STATE OF MAINE
DEPARTMENT OF TRANSPORTATION
16 STATE HOUSE STATION
AUGUSTA, MAINE 04333-0016

July 18, 2024
Subject: Bridge Deck
Replacement
State WIN: 025631.06
Location: Pittsfield
Amendment No. 2

STAGE I CONSTRUCTION
I-95 Northbound shown.
I-95 Southbound opposite hand.

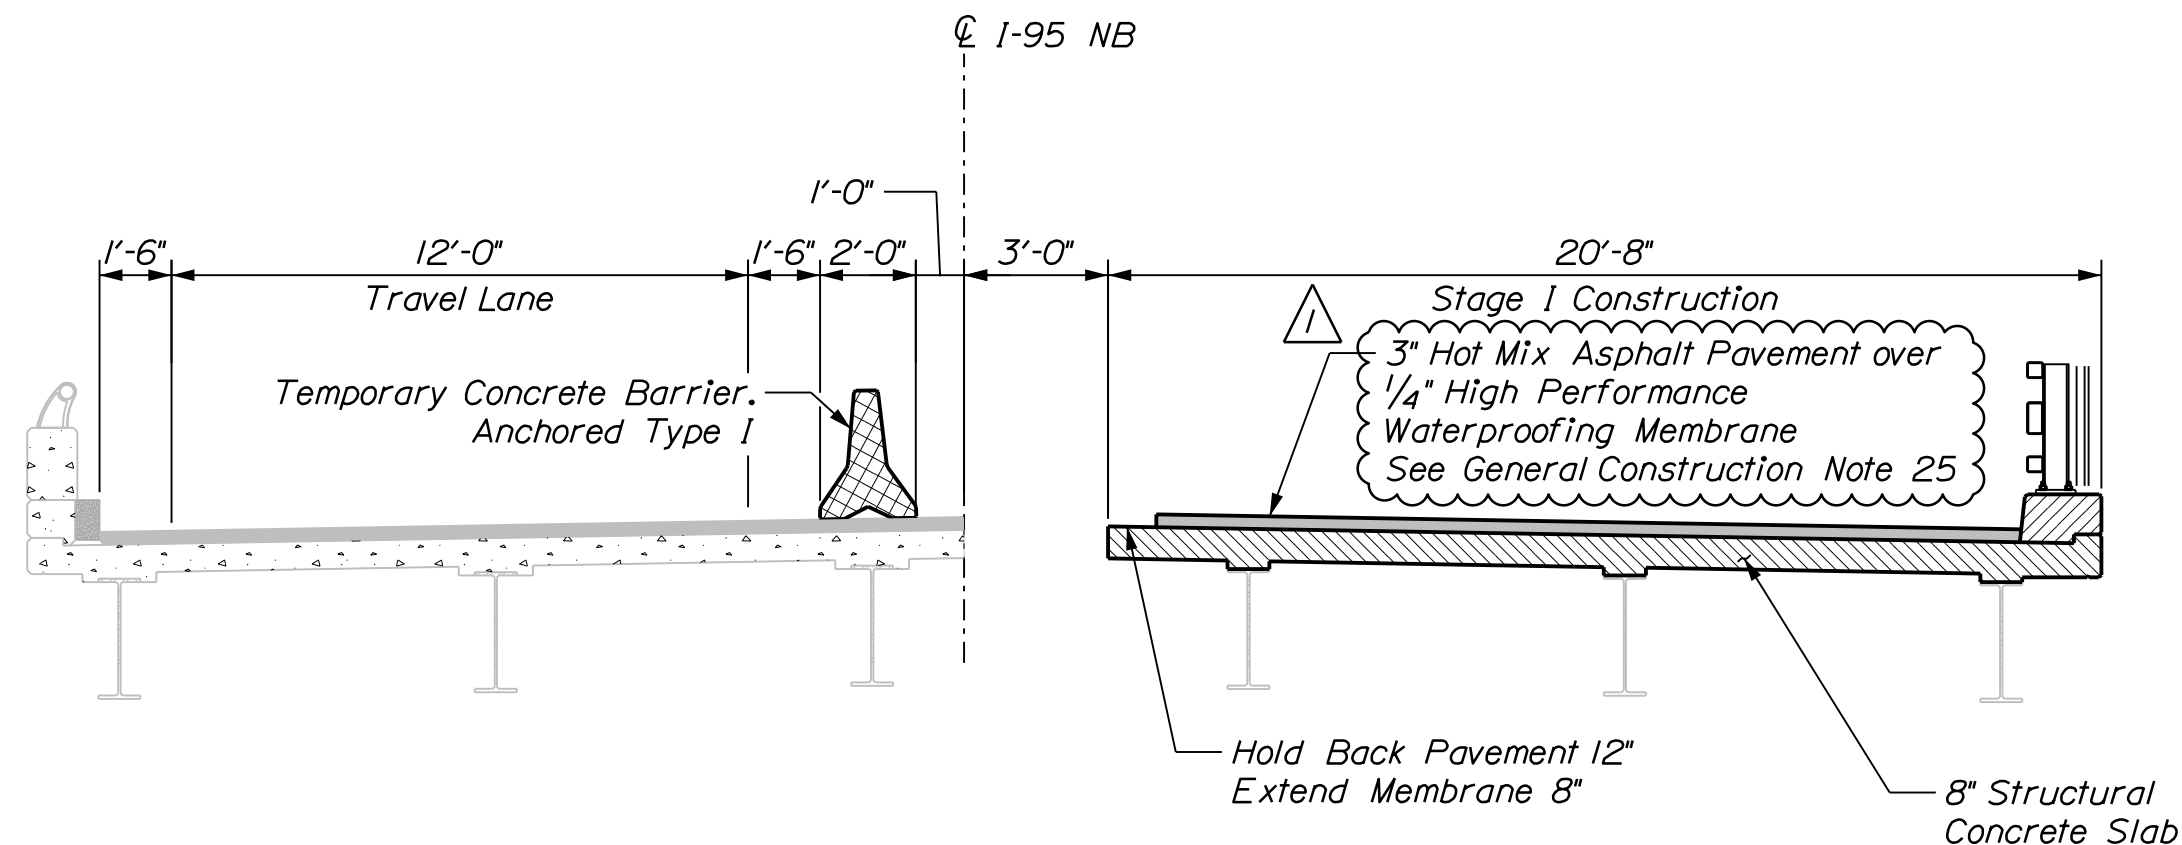
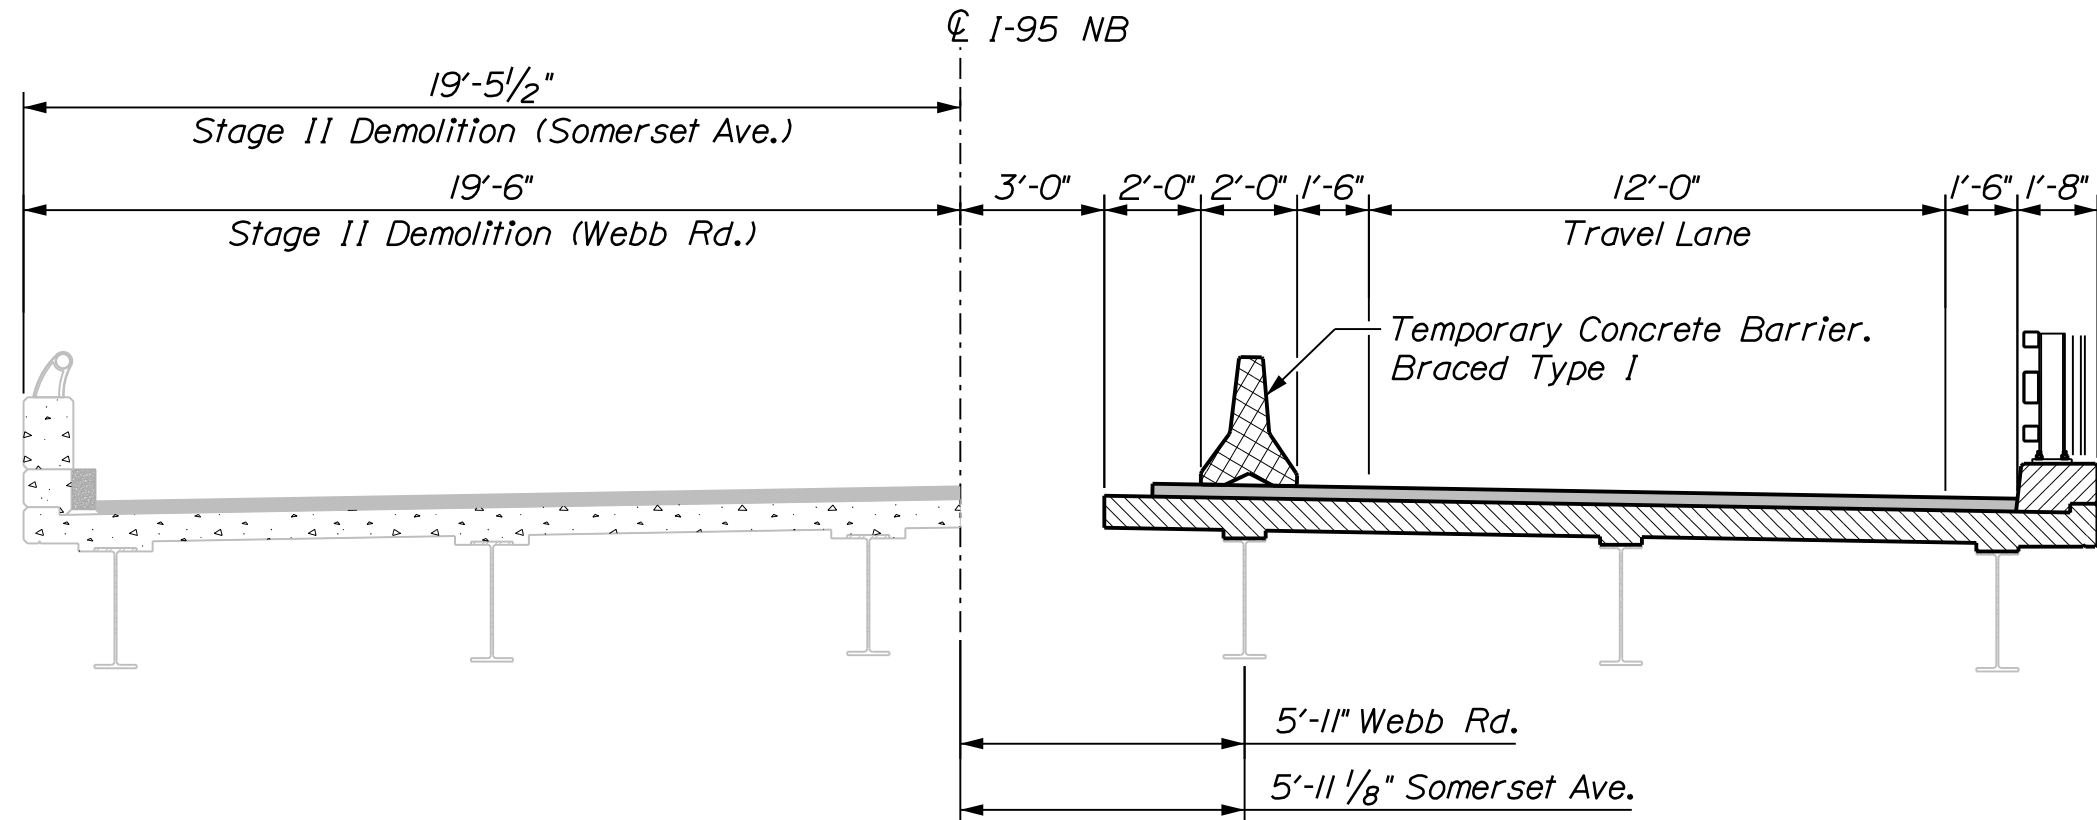
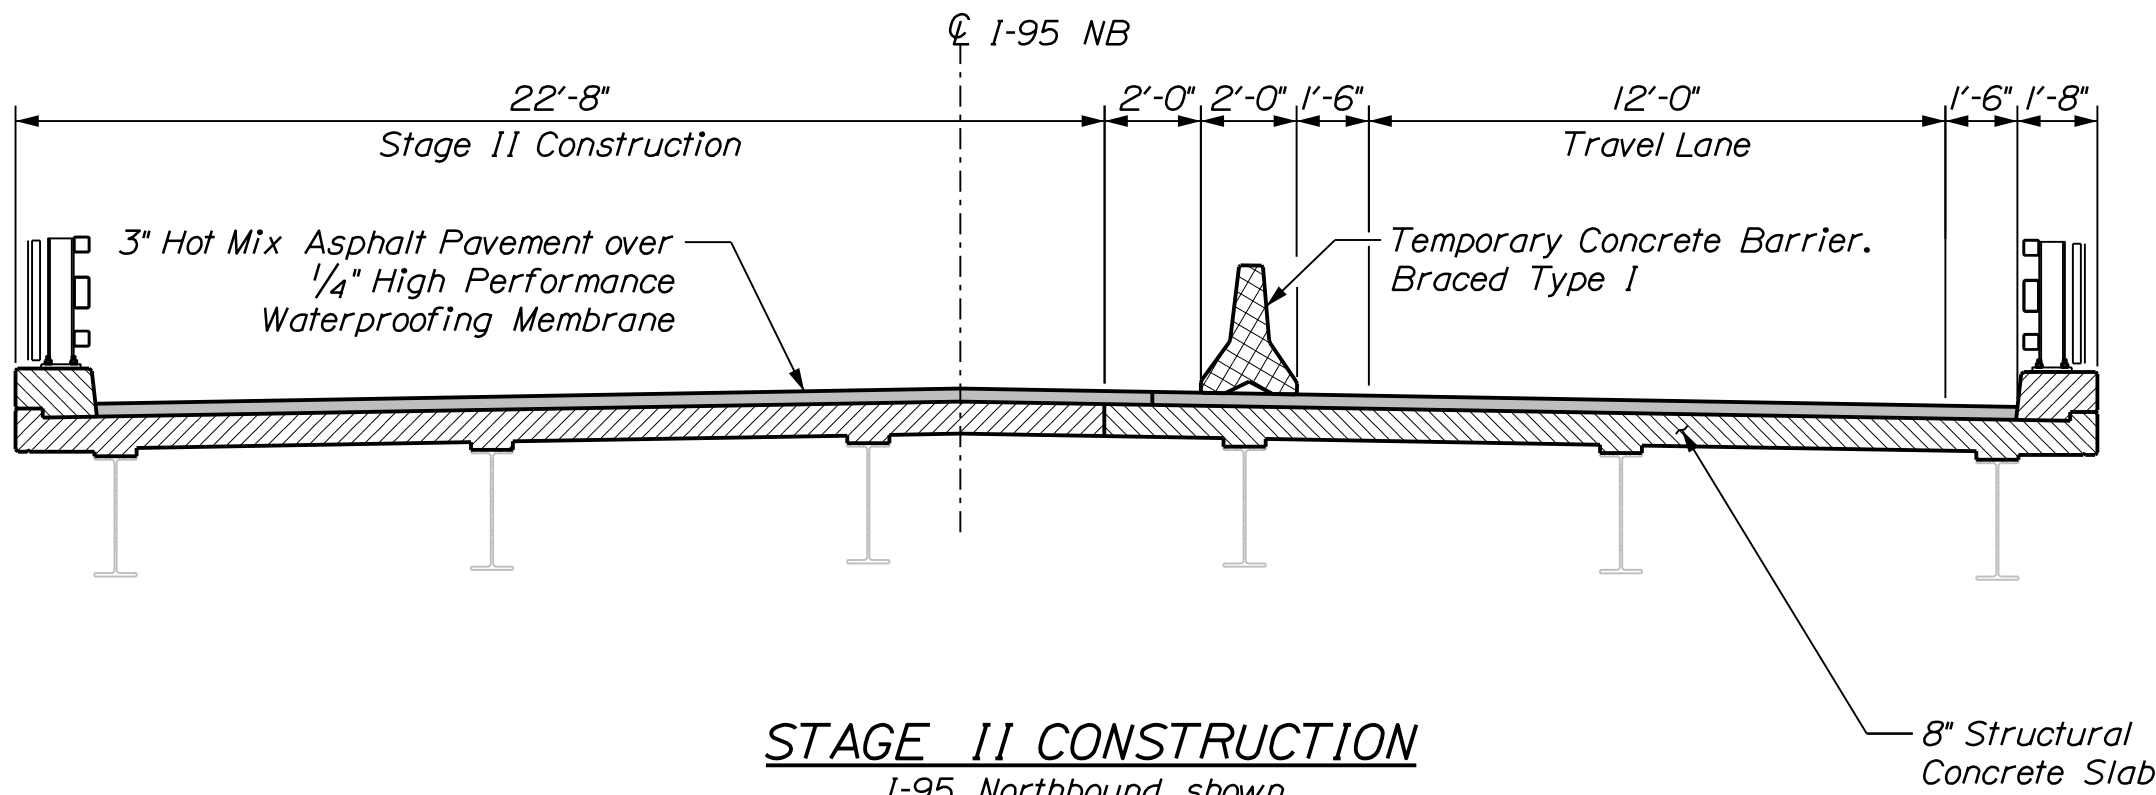
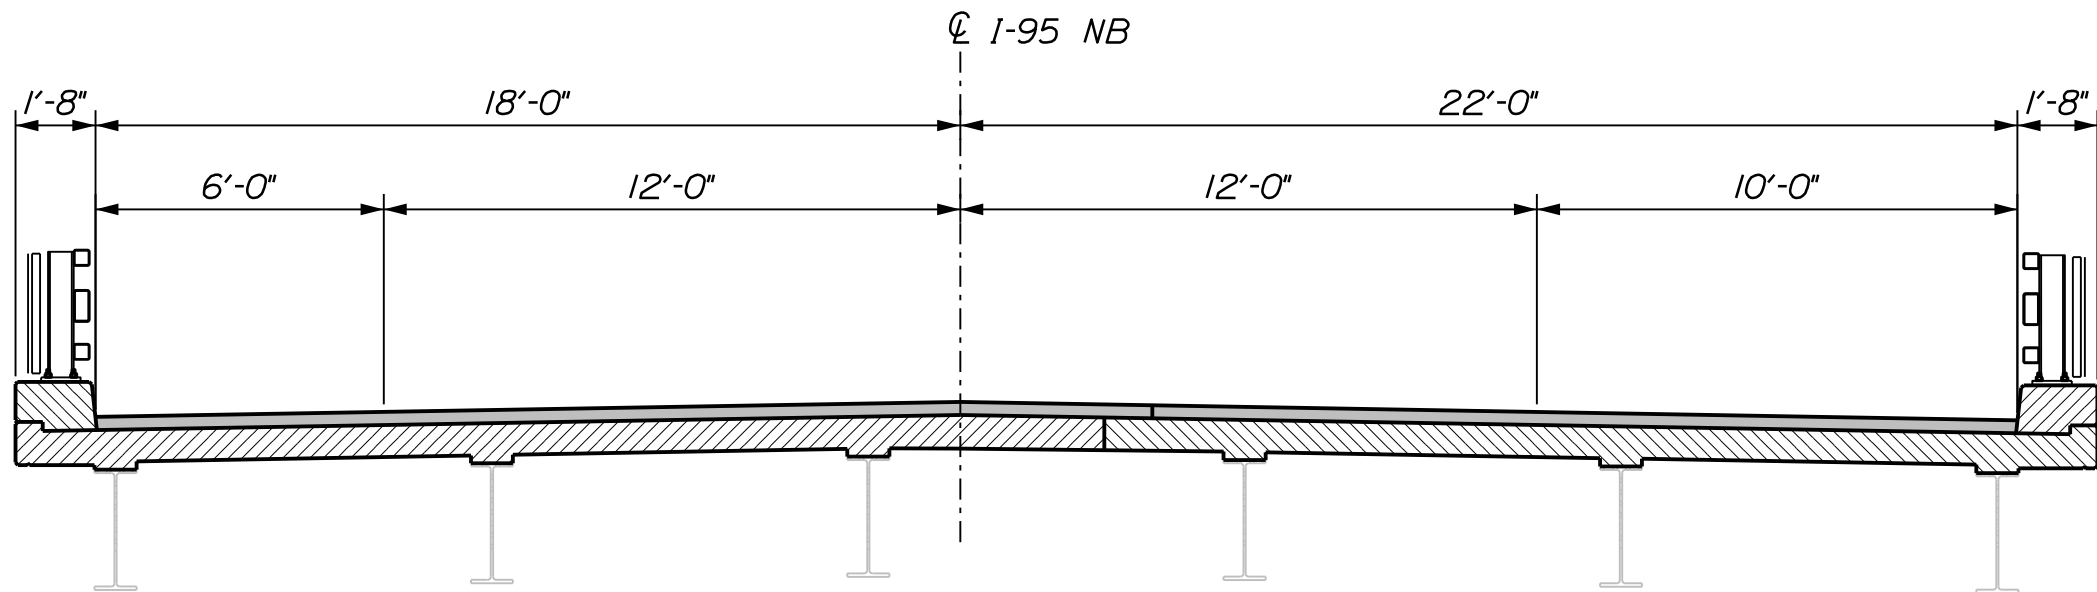
Given this would the Department allow the contractor to place the phase one bridge decks with additional thickness (sacrificial concrete wearing surfaces) and mill them off after phase 2 is completed?

PROJ. MANAGER	J. BRASKY	BY	DATE
DESIGNED-DETAILED	S. LINDSLEY	E. MORRISON	06-24
CHECKED-REVIEWED	D. WHITE	B. COLBURN	06-24
DESIGNED-DETAILED	N. EDMAN	J. FITZ	06-24
DESIGNED-DETAILED	Added Note to Stage I		07-24
REVISIONS 1			
REVISIONS 2			
REVISIONS 3			
REVISIONS 4			
FIELD CHANGES

Response: Yes, as described in the General Construction Note 25 added to Sheet 4. If the Contractor chooses to use a temporary wearing surface for Stage 1, Pay Items 910.301 are added to pay for the placement and removal of it. In addition, Special Provisions 401 and 631 and Pay Item 631.165 are added to the Contract Documents to mitigate some of the time and temperature constraints for paving.

- Due to the short fall construction season, the Contractor may place a temporary wearing surface in Stage 1 and remove it before final paving of both Stage 1 and Stage 2. The following options are allowed:

a. Cast an 8" concrete deck. Pour a 3" temporary concrete wearing surface with a 1" thick foam bond breaker at curb line against the curb. Remove the temporary concrete wearing surface before installing membrane and final paving.

b. Cast a 9" concrete deck including 1" integral concrete wearing surface. Place 2" of temporary pavement. Remove the temporary pavement and mill off the additional 1" of concrete before installing membrane and final paving.
